Project Name: Coastal Business Park (2018-200)

Request: Class V Site Plan

SITE PLAN REVIEW AND APPEARANCE BOARD STAFF REPORT

Meeting: December 12, 2018 | File No.: 2018-200-SPF—SPR-CL5 | Application Type: Class 5 Site Plan – Coastal Business Park

PROPOSED SITE PLAN

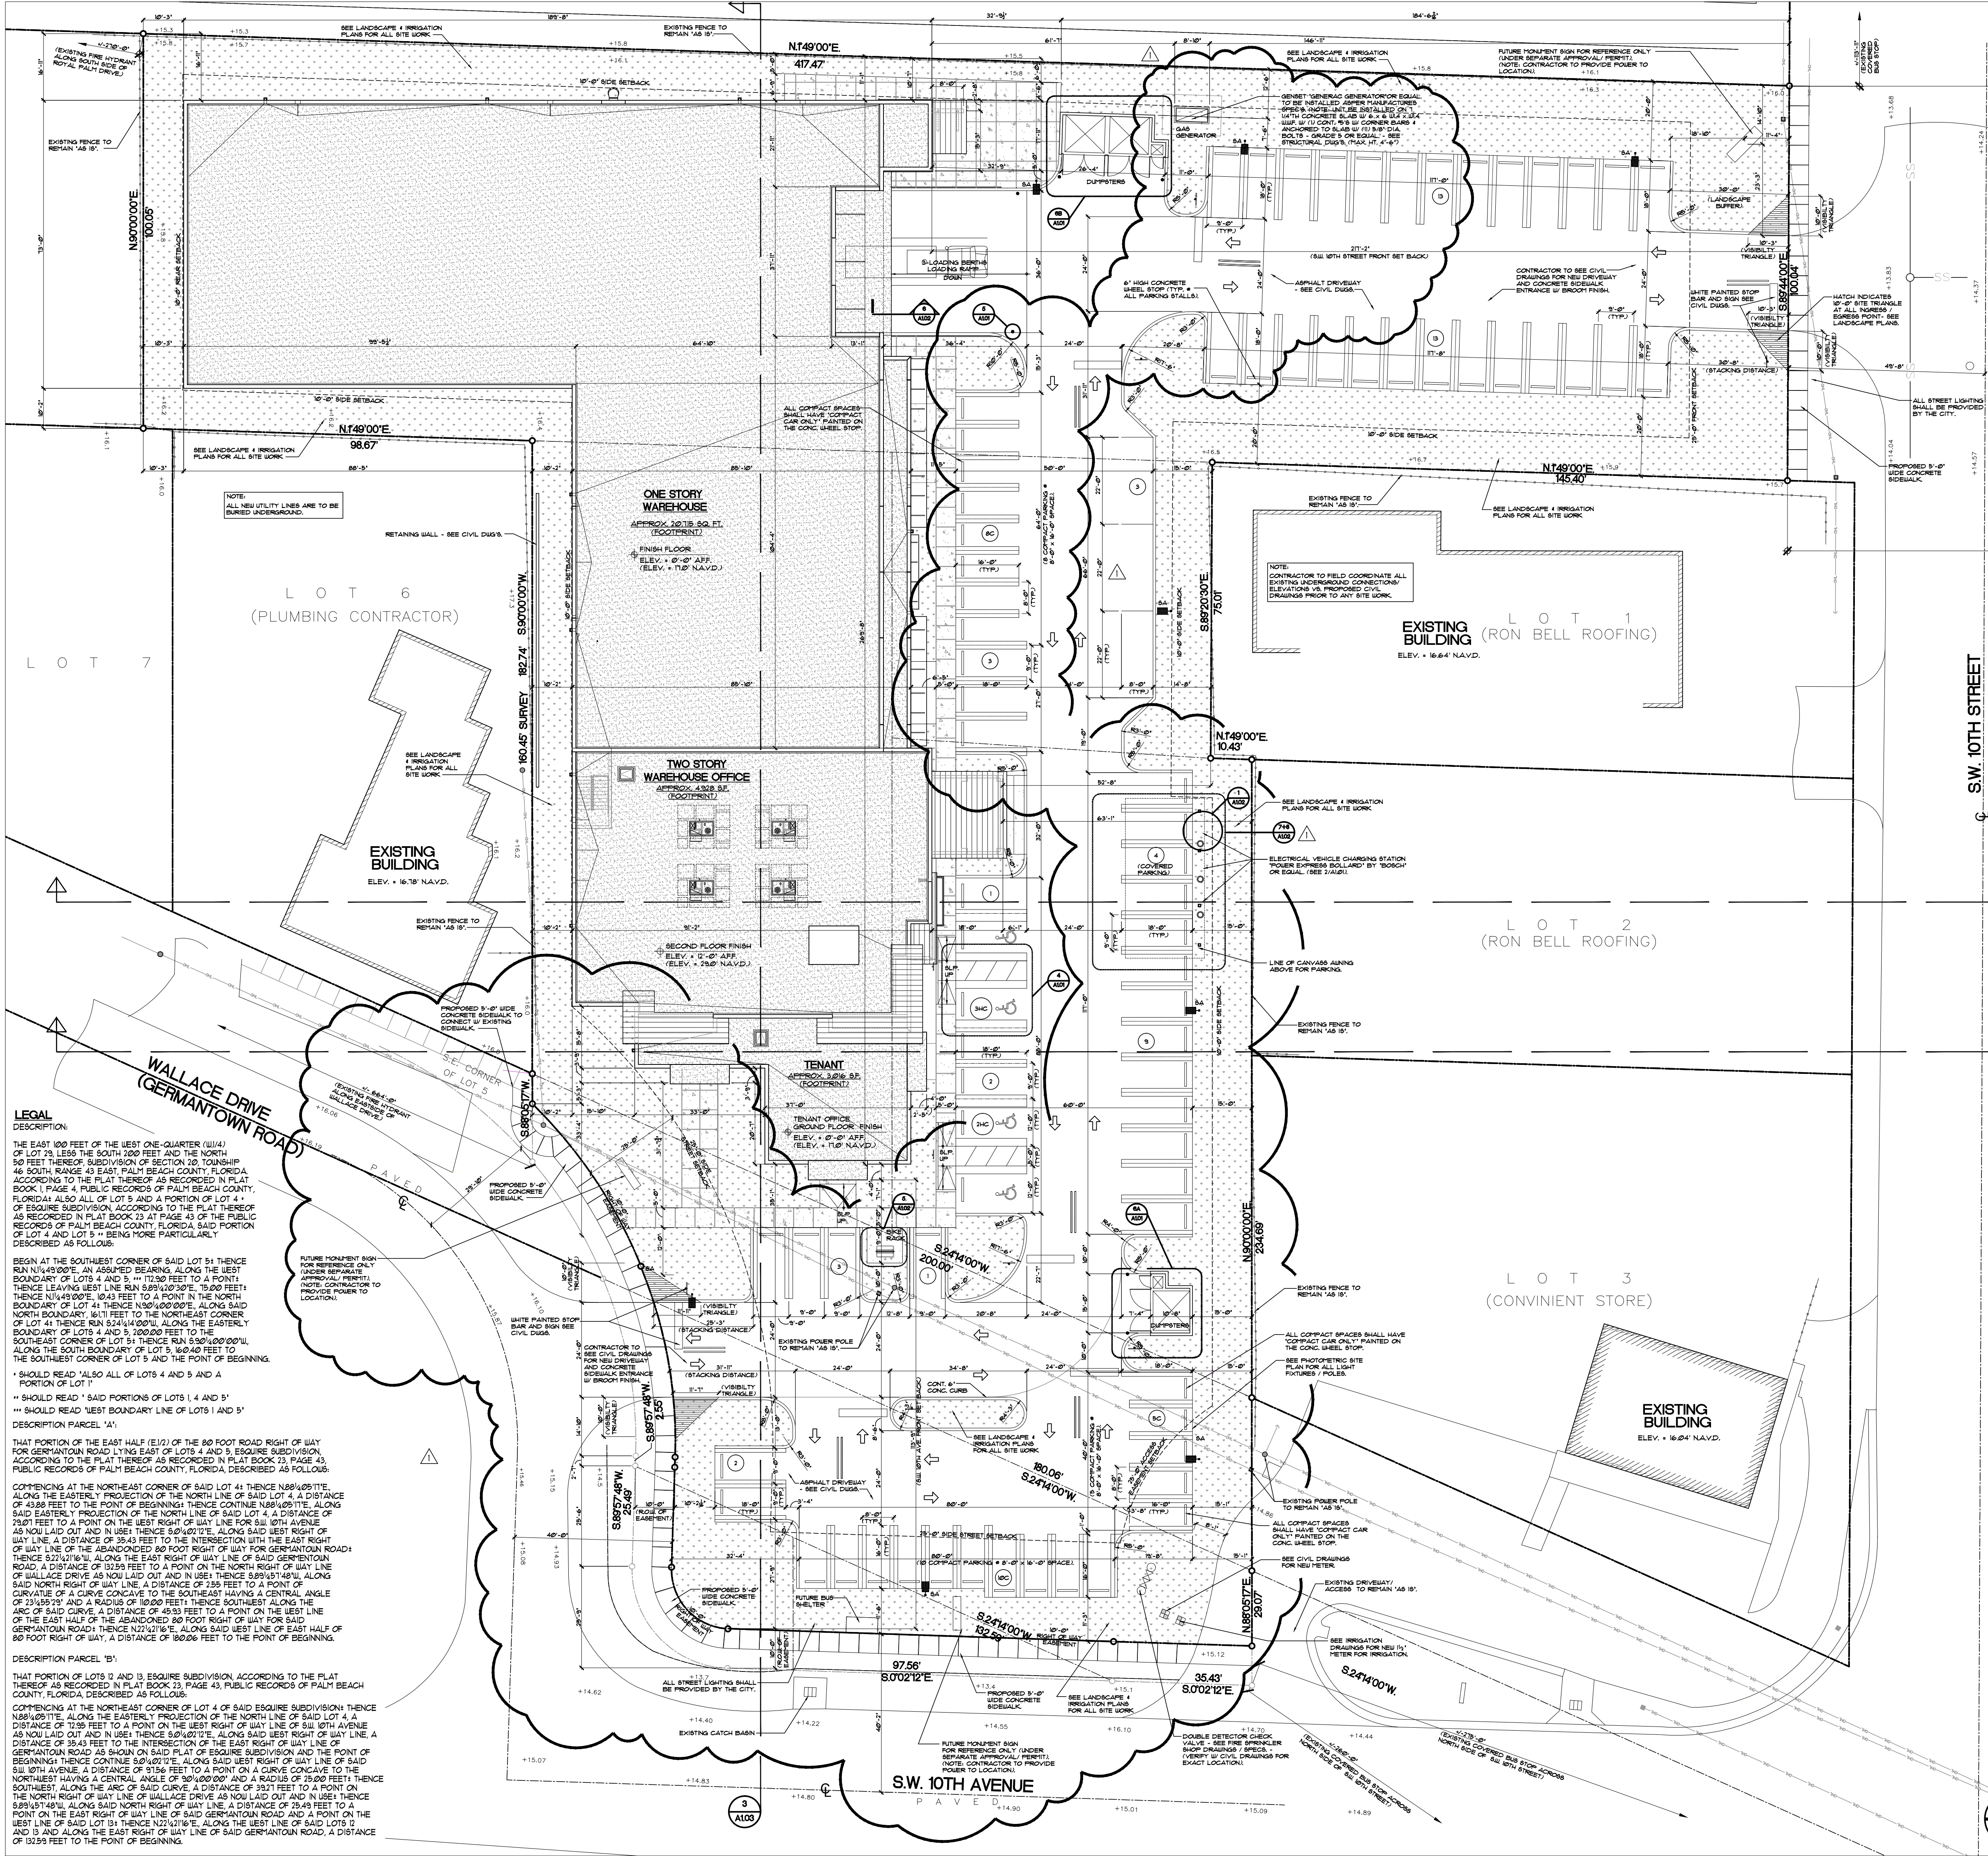
- ✓ According to the 2012 Florida Accessibility Code, the applicant is required to provide 4 handicap parking spaces for required parking between 76 to 100 spaces. As indicated on page A1.00, the applicant is providing 4 handicap spaces; thus, meeting this requirement.

- ✓ As shown on sheet A1.00, the applicant is providing 24' wide driveway approaches at both entrance on to the site (SW 10th Street, and Wallace Dr.) Furthermore, the applicant is providing continuous 24' wide two-way drive isles throughout the site. Therefore, this requirement has been met.

- ✓ As shown on sheet A1.00, the site has been designed with two access points, one off of SW 10th Street and the other off of Wallace Drive. For parking lots designed and operated with two or more access points, the stacking distance may be reduced to 20' subject to staff analysis. The applicant has shown on their plans a stacking distance at the Wallace Drive entrance of 25'-3" to the first parking space, and a stacking distance of 30'-8" at the SW 10th Street entrance. As such, the applicant has met the criteria for a reduced stacking distance by providing two points of access with stacking distances exceeding the minimum distance required, thus meeting this requirement.

- Pursuant to **LDR Section 4.6.9 (C) Loading Berths**, for manufacturing or processing, research and development type development with 40,000 to 65,000 gross square feet of area, three berths are recommended.
 - ✓ As shown on sheet A1.00, the applicant is providing three loading berths meeting the dimensions for single units listed in 4.6.9 (D), thus meeting this requirement.

- ✓ As shown on A1.00, the applicant has shown a 10' roadway dedication to the City to contribute to the expansion of the R-O-W along Wallace Drive. Additional, though not required, the applicant is providing a 10' dedication along SW 10th Avenue. The additional easement will allow the City to access utilities outside the property line, thus complying with this requirement.

Sheet:
LP-1
Of: Two

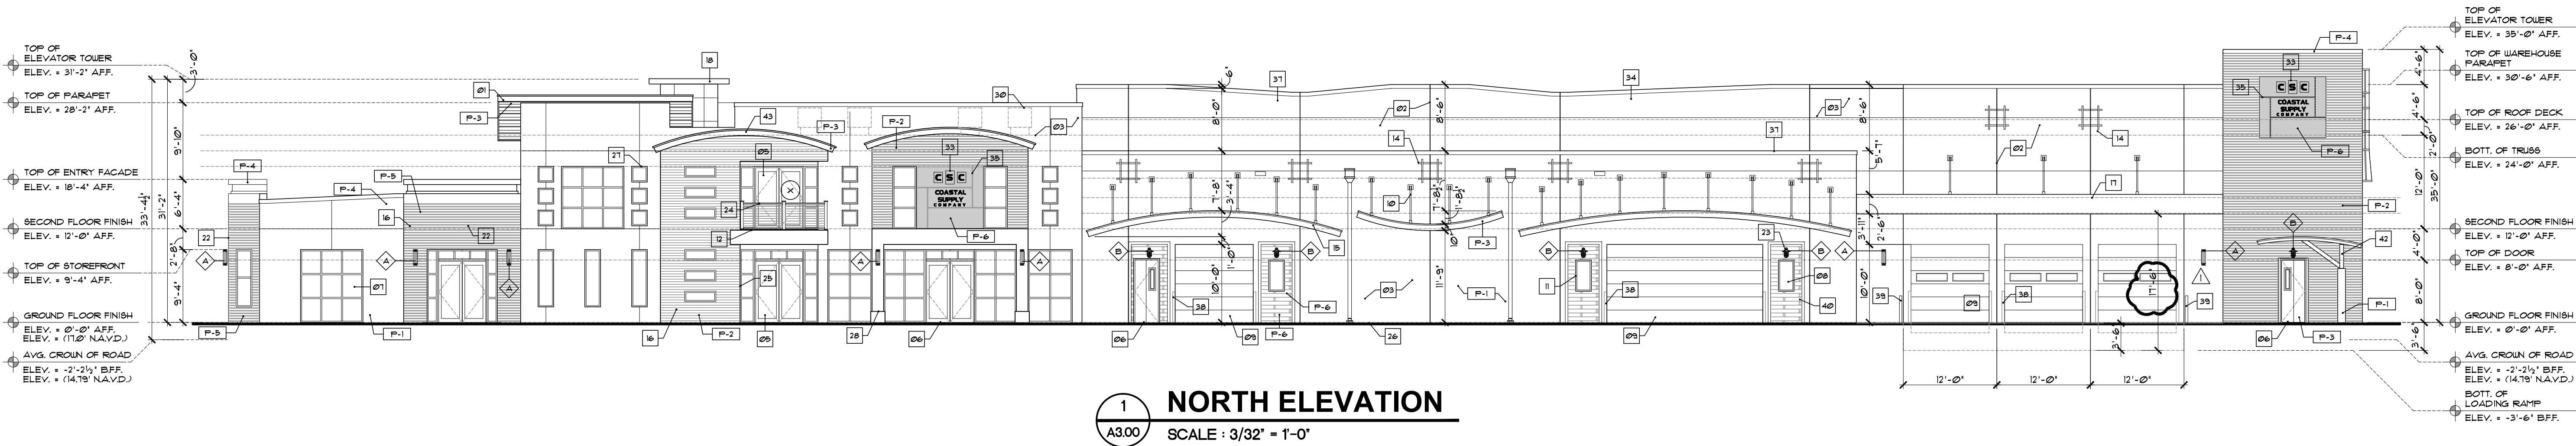
- ✓ As shown on page LP-1, the applicant is providing at least 135-sf of planting area in landscape islands and bulb-outs at the at the end of every group of parking spaces. Each group has less than 13 parking spaces. Therefore, the applicant has met the minimum requirement for parking islands.

- ✓ As shown on page LP-1, the applicant is providing 4.5' foot tall "Yew Podocarpus" shrubs for landscape screening around the dumpster enclosures and generator slab. The mechanical equipment is shown on page A1.00 on the roof and be screened by a parapet wall. Thus, this requirement has been met.

3. That the applicant updates the landscape plans showing all the utility easements prior to site plan certification.
4. That the applicant updates the landscape plans to show existing trees to remain or be removed prior to site plan certification.
